AMENDMENTS TO THE DRAWINGS

App No.: 09/867,846

Title: LOCK IN PINNED PHOTODIODE PHOTODETECTOR

FIG. 1

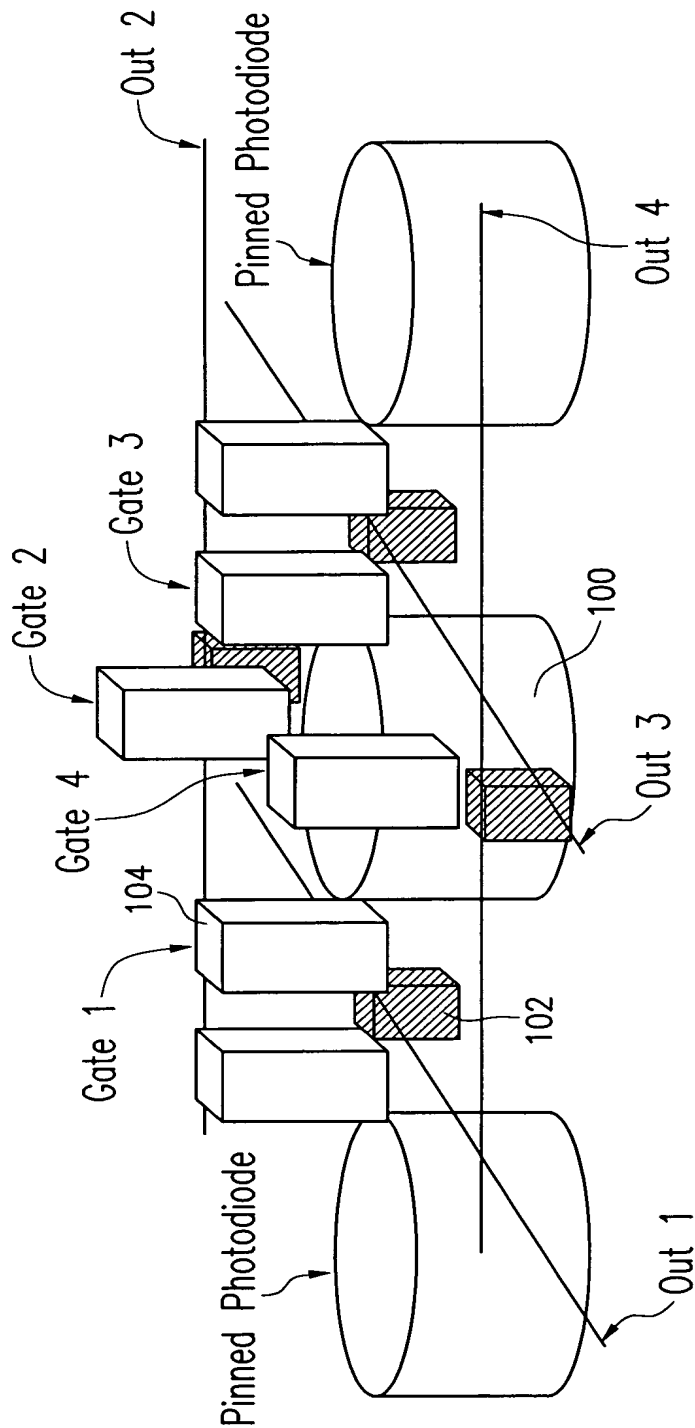
The attached drawing sheet includes changes to FIG. 1. Specifically, reference characters “out1,” “out2,” “out3,” “out4,” “gate1,” “gate2,” “gate3,” and “gate4,” as described in the specification, have been added. Further, the shading has been removed for a “pinned photodiode” portion.
